1. Mosman High School – Response to Submissions

ptc. has been engaged by Multiplex on behalf of School Infrastructure NSW (SINSW) to address comments received following the State Significant Development Application (SSDA) submission of the Mosman High School project located at 745 Military Road, Mosman.

Figure 4 – Access Points

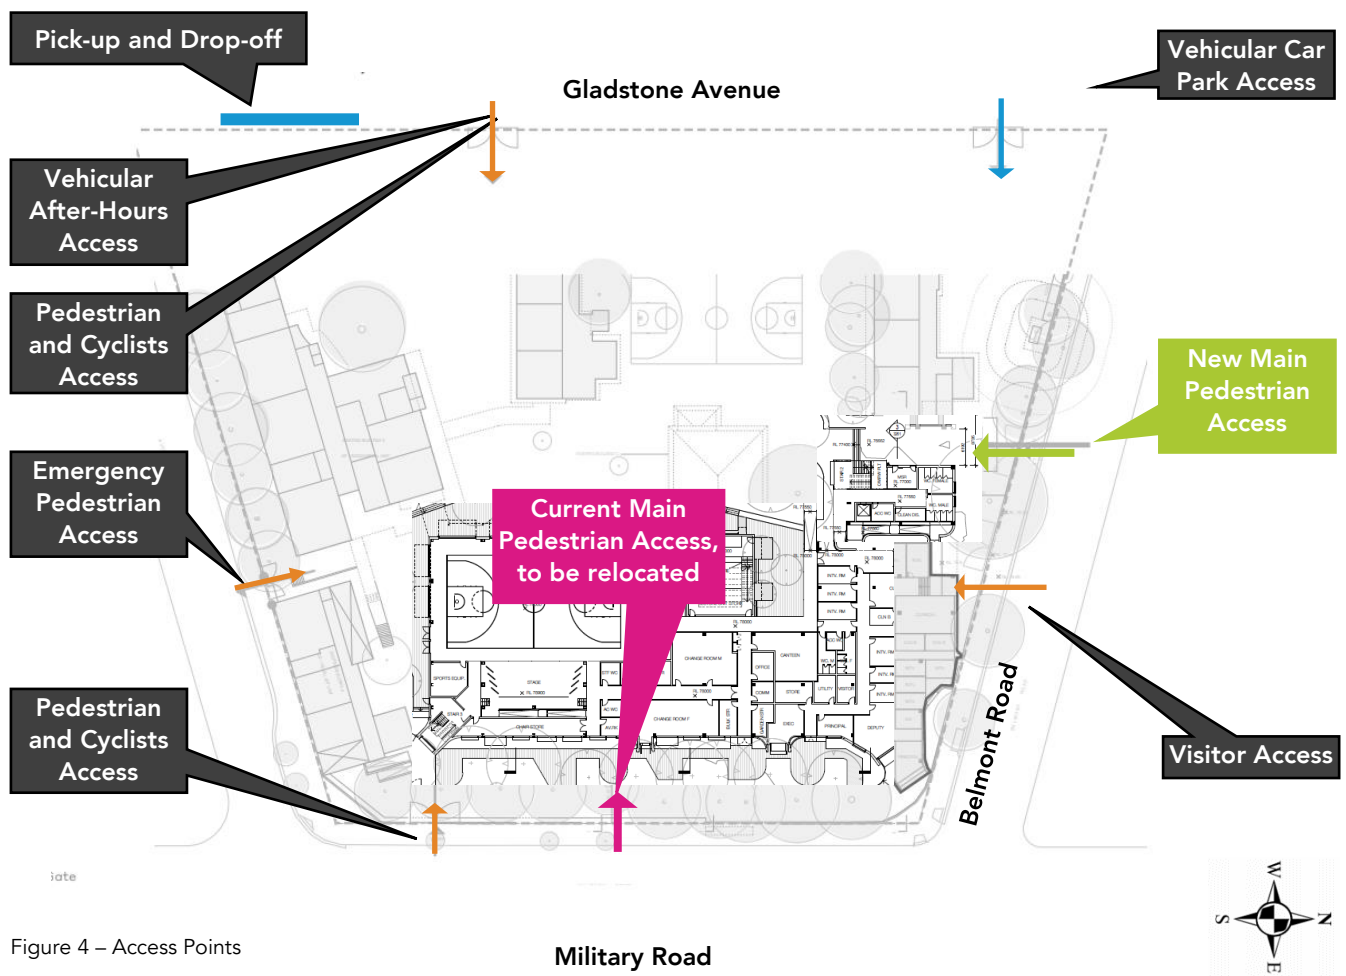
Relocating the main entrance to Belmont St is sensible, but raises some traffic issues. Travel by car would involve either a right turn at Military Road, or children crossing Belmont Road. Drop off parking zones should be added on each side of the road (Mon - Fri) to ensure safe access. The existing zebra crossing, while currently well sited, may be too far from the new entrance & tempt short cuts, so consideration should be given to a subsidiary entry point aligned with the crossing, separated from the staff parking area.

It is not anticipated that the relocation of the main entry will resolve in major changes to traffic behaviour. As shown in Figure 4, the current main pedestrian entry along Military Road (pink arrow) is proposed to be relocated to Belmont Road (green arrow), while all other access points will be retained at their current location (orange arrows). There will still be an access point off Military Road for students arriving from the south.

The zebra crossing across Avenue Road remains aligned with the access point off Military Road. The zebra across Belmont Road will provide the same connectivity as it currently does to the pedestrian gate off Belmont Road. An additional zebra crossing is being investigated across Gladstone Avenue to improve the pedestrian connectivity between the school and the area towards the west. There is a pedestrian access gate located on Gladstone Avenue near the proposed zebra crossing. The school will remain to provide pedestrian access points on three frontage roads, and all students do not need to access the site via main pedestrian access gate.

The existing pick-up / drop-off area is located on Gladstone Avenue and no changes are proposed this arrangement; the access will continue operating as per the existing situation. The vehicles accessing the drop-off / pick-up area will continue the existing behaviour and the relocation of gates is less likely to have any effect on it. The investigation of pick-up and drop-off demand indicates that the existing facility is sufficient. This aligns with the principal's observations.

Figure 5 – Photo of signage dedicating an area to motorbike parking within the school's car park

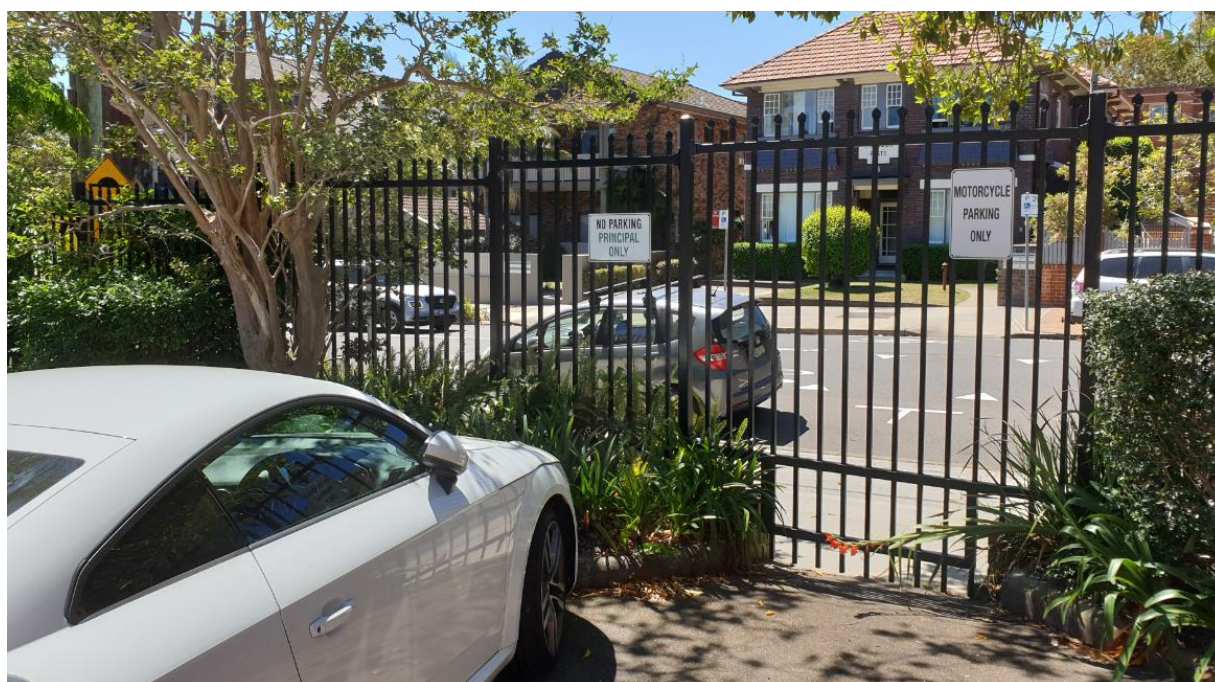
Very few students ride bicycles to school – the addition of Motor/Electric Bike parking at school is welcomed (However, PTC report 7.6 is incorrect). Students like riding motor bikes and motor scooters and these have not been counted accurately. Any new development will expand this vehicle demand further and consideration should be made for future EV car charging/bike/scooter trends.

As stated in the TIA, there is an area within the school car park dedicated to motorcycle parking, please see the below figure showing the signposted area.

Figure 6 – Year 12 responses to "How do you travel to / from school on a typical day" (l: AM, r: PM)

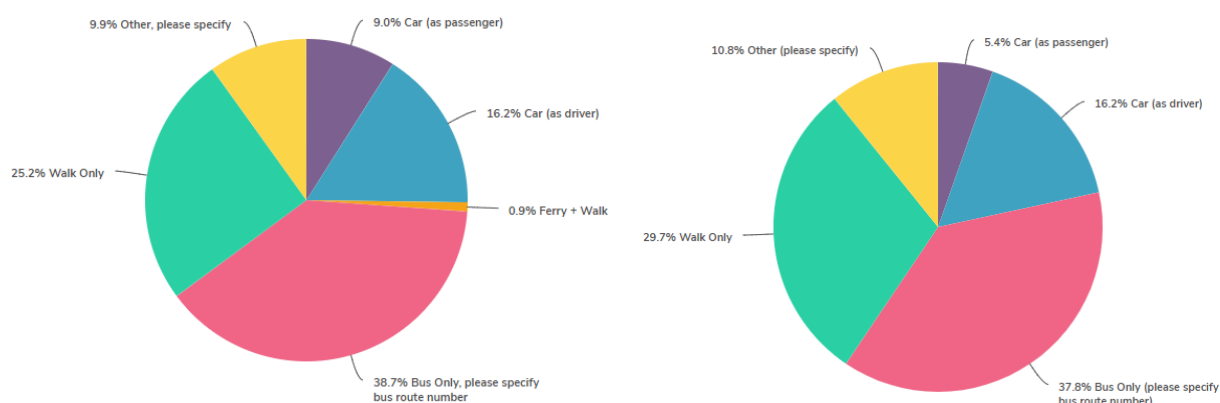
PTC TRAFFIC IMPACT ASSESSMENT. (SECTION 4.1). This document is misleading and factually wrong. To be fair the report acknowledges the basic structural error of the school survey in Section 4.1. Evidence: An entire year of students (year 12 HSC) had graduated at the survey date. At that time of survey the school was missing 16% or more of the student population (4.1.1.1) possibly as much as 50% of all student parked cars - They nearly all drive to school by HSC exams. As the calendar year progresses, more class years of students qualify for "P's". The volume of student parked cars expands every month in the surrounding neighbourhood streets. Increase students – Increase parked cars. Not 6 afternoon vehicles – a rubbish statistical "fun model fact" based on a flawed transport survey 6.2 SIDRA model. This model is factually incorrect and the PTC TRAFFIC ASSESSMENT should be rejected by the planning authorities and courts.

Figure 6 shows responses from Year 12 students to the question "How do you travel to / from school on a typical morning" and it is shown that 16.2% drive. With a student population of 1,200 students and an assumption of an even distribution of students between the year groups, 32 students are expected to drive to school and therefore generate parking demand.

With a potential increase of Year 12 students by 16 (out of the 100 overall increased student population) and with a car usage of 16%, this would result in an increased parking demand generated by the development by 3 cars.
